Docket Item #7
DEVELOPMENT SPECIAL USE PERMIT #2003-0032
SOCIETY OF AMERICAN FLORISTS

Planning Commission Meeting
February 1, 2005

- ISSUE:** Consideration of a request for a development special use permit, with site plan, for the redevelopment of an office building to include ground floor retail, below grade parking and a request to include the operation of restaurant on the ground floor.
- APPLICANT:** The Society of American Florists and Ornamental Horticulturists
by Duncan Blair, attorney
- LOCATION:** 1601, 1603 and 1607 Duke Street
- ZONE:** OCH/Office Commercial High
-

Expanded Plaza Planters with Ornamental Trees

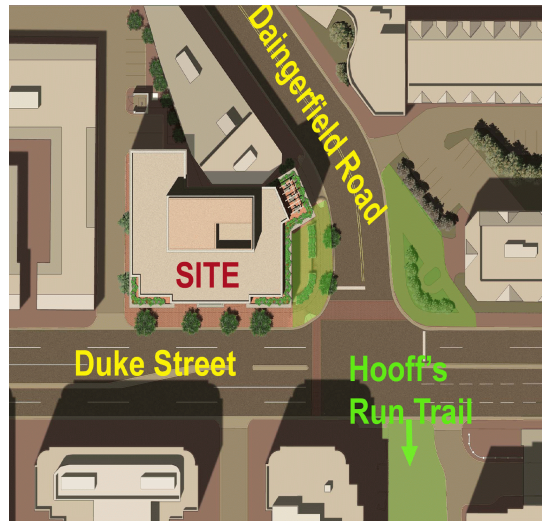
Located on the northeast corner of Daingerfield and Duke across the street from this site is an urban open space-pocket park area. An initial staff recommendation was to provide a setback for the building on the eastern portion of the site to provide a better transition to the buildings on the eastern portion of the site. The applicant responded by providing a 35.8 ft. setback along Daingerfield Road, compared to the 60 ft. setback on the opposite corner across Daingerfield Road (50 ft. of which is public right-of-way). The proposed space will be visually accessible and may function as outdoor dining space if the applicant is successful in securing a restaurant.

The proposed corner open space will retain some of the “openness” of the current site, although due to the height and scale of the proposed building, the character and current amount of “openness” will be reduced. In evaluating the proposal, staff has considered the need for open space and openness with landscaping and pedestrian improvements. While the amount of “openness” will be decreased, the amount of landscaping and pedestrian improvements on the corner will be significantly increased. With the proposed 35.8 ft. setback on Daingerfield Road, additional landscaping and pedestrian improvements, the proposed corner open space provide a reasonable amount of “openness” and open space on the corner.

9. The open space courtyard-plaza at the corner shall be revised as generally depicted in *Attachment #1* to decrease the amount of hardscape and increase the amount of landscaping to the satisfaction of the Director of P&Z. The courtyard-plaza shall also provide the level of detail and amenities depicted on the preliminary plan, and shall also provide the following:
